Wanipigow Sand Extraction Project

Notice of Alteration

Canadian Premium Sand Inc.

November 2022

Figure 2-1: Updated Project Site Layout

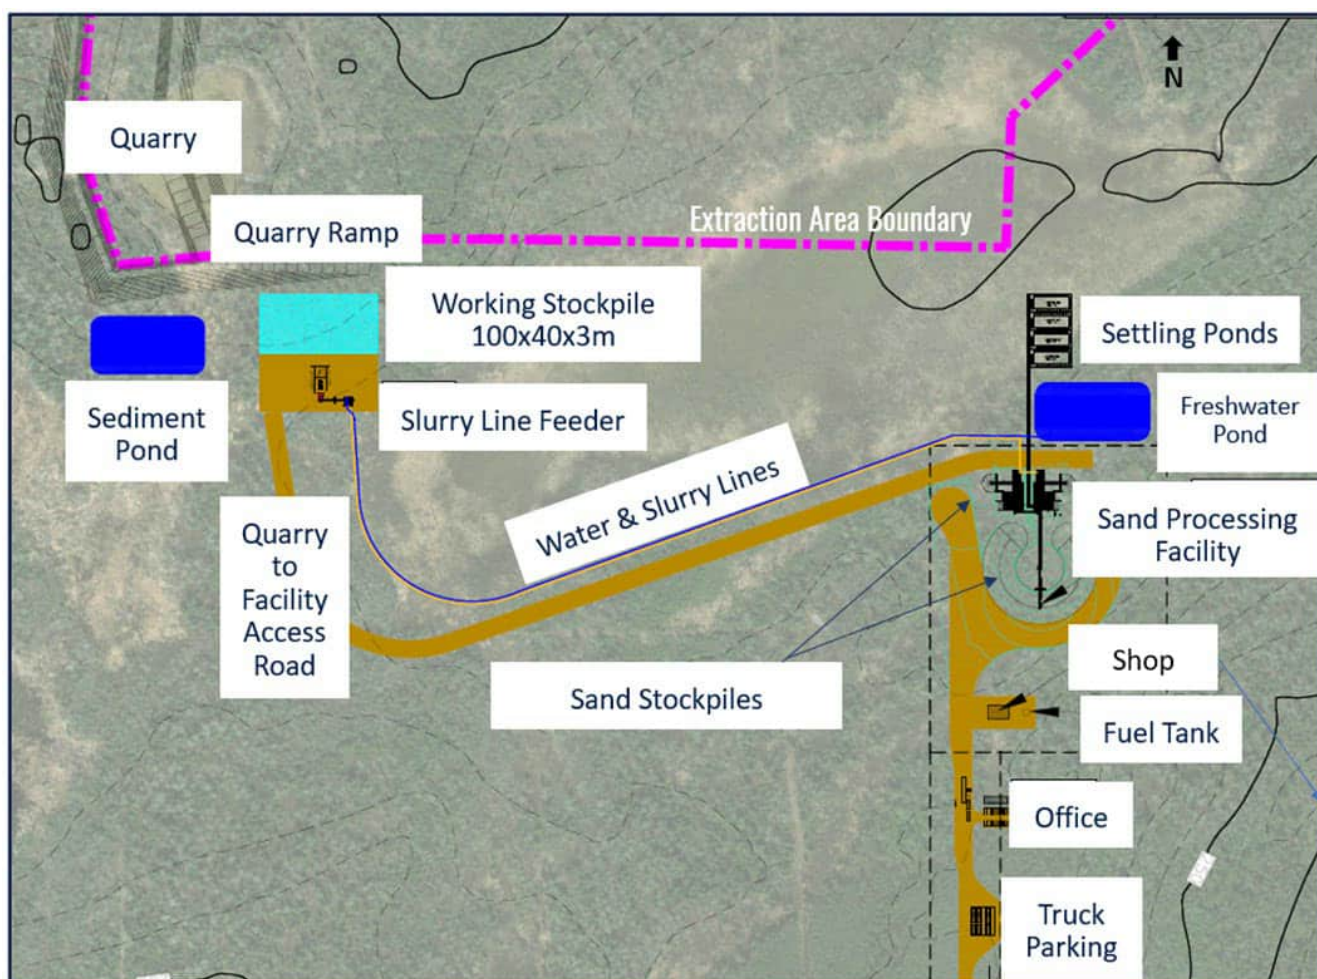
- Revise the Project process flow, stockpiles and layout of Project components within the previously proposed Project site;
- Modify how sand is transported from the quarry to the wet sand processing facility (use of water and slurry lines); and

- Add water and wastewater management components within the previously proposed Project site.

The Project will require the addition of the following components within the Project site:

An updated Project site layout is provided in **Figure 2-1**.

Figure 2-2: Updated Sand Extraction Areas

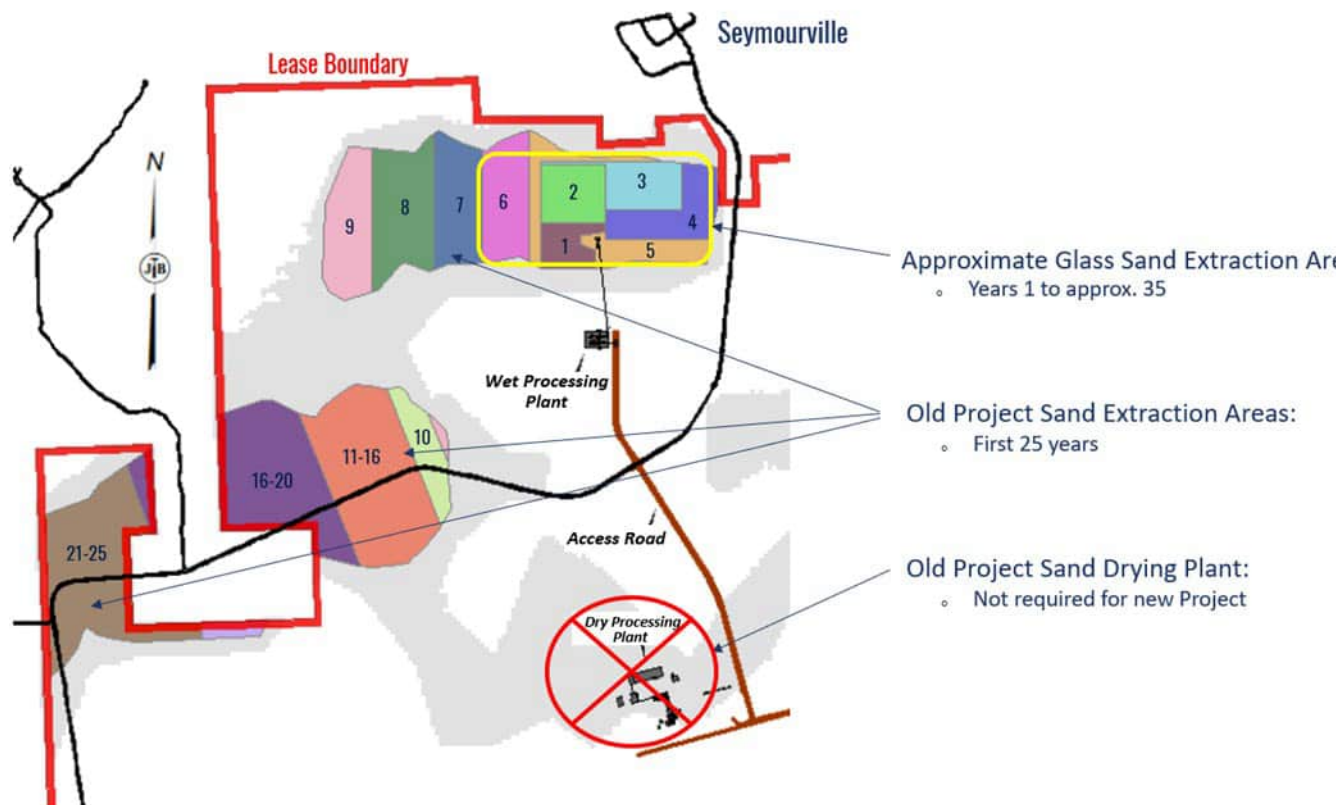
- Sand quarrying taking place 10 hours per day, seven days per week for approximately seven months per year except during extreme weather events.

The sand extractions areas for the new Project design (for the approximate 35-year life of the Project) compared to the old Project design are illustrated in **Figure 2-2**.

Figure 2-3: Simplified Anticipated Process Flow Diagram

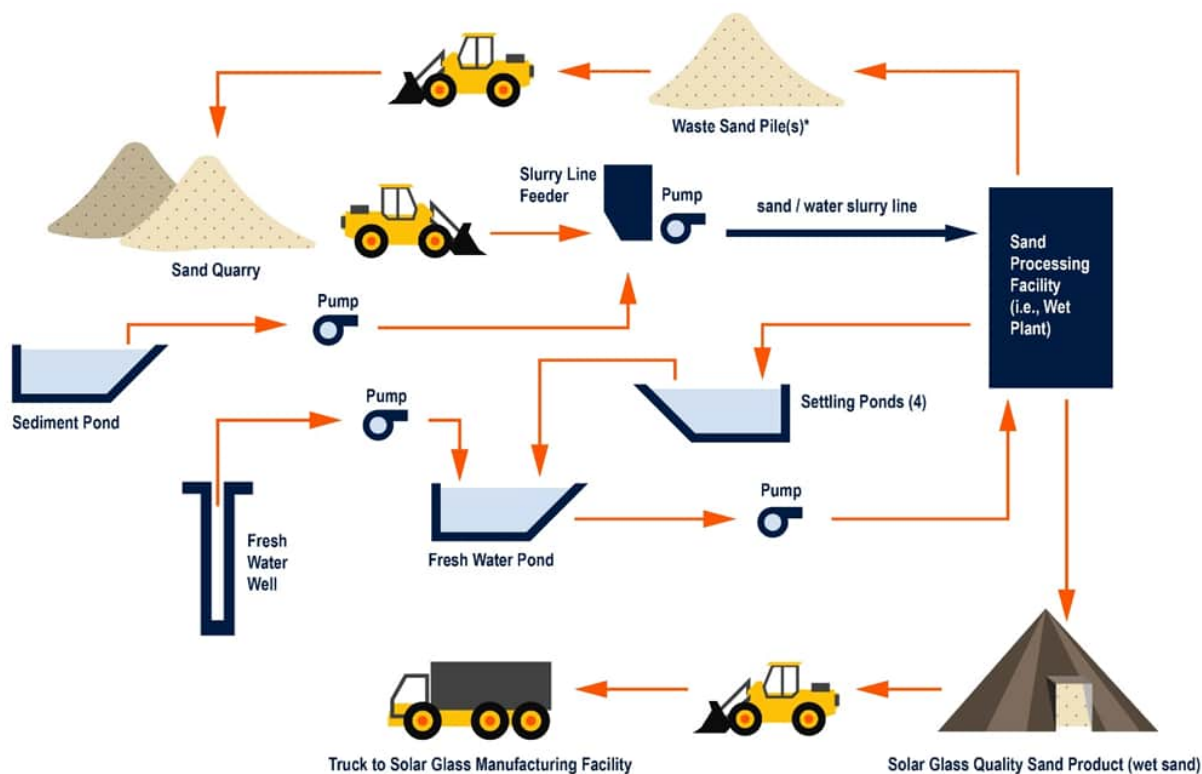
The purpose of the revised wet sand processing plant is to produce sand of the correct grain size and reduced iron content suitable for solar glass production. The sand does not need to be dried (and therefore will not be dried) at the Project site before being transported by truck to the proposed solar glass plant in Selkirk, Manitoba.

A detailed diagram illustrating the wet sand processing flow is provided in **Appendix A**. A simplified version of the sand processing flow is illustrated in **Figure 2-3** and is summarized below.

Figure 2-4: Updated Main Access Road vs. Previous (old) Alignments

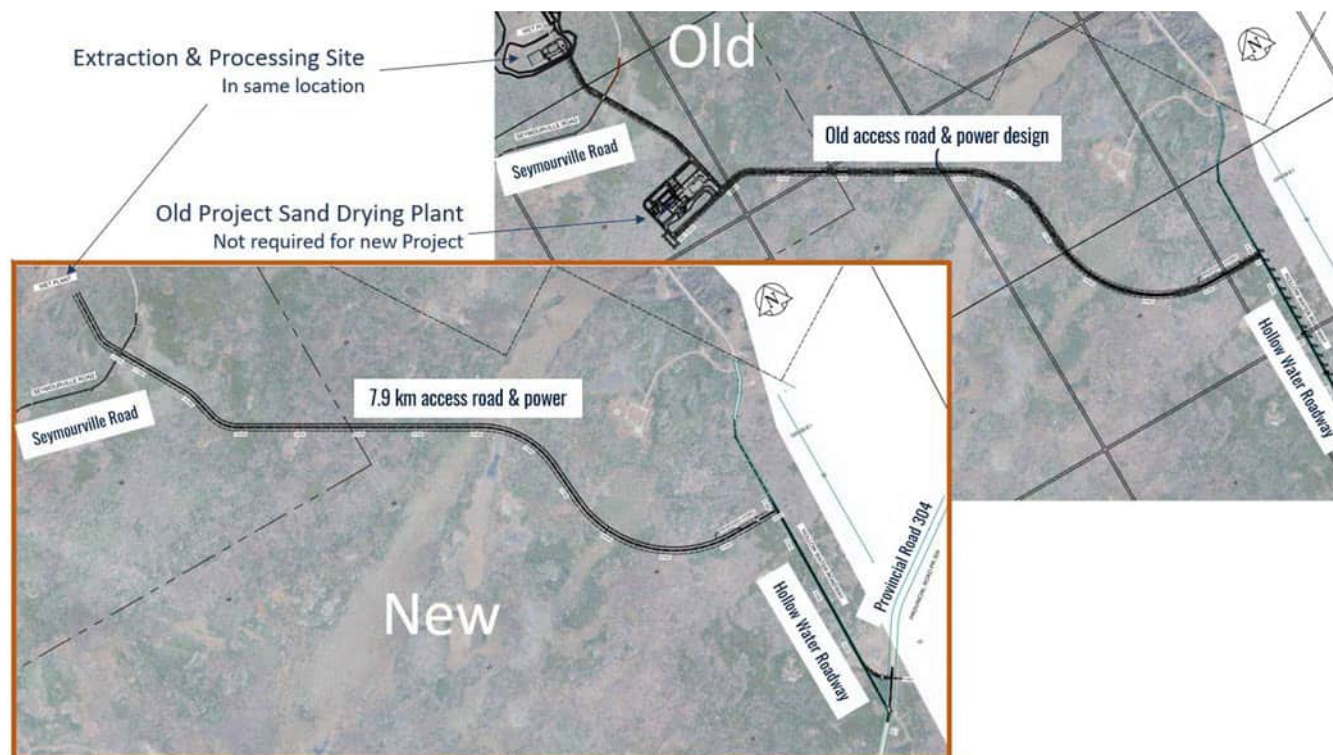
- gravel rather than paved (with seasonal road dust control);
- will have minor adjustment to the alignment (due to the dry plant no longer being required); and
- the total length has been modified from a conceptually estimated 6 km to 7.9 km during the advanced design stage.

The updated access road alignment compared to an iteration of advanced design for the old Project is shown in **Figure 2-4**.
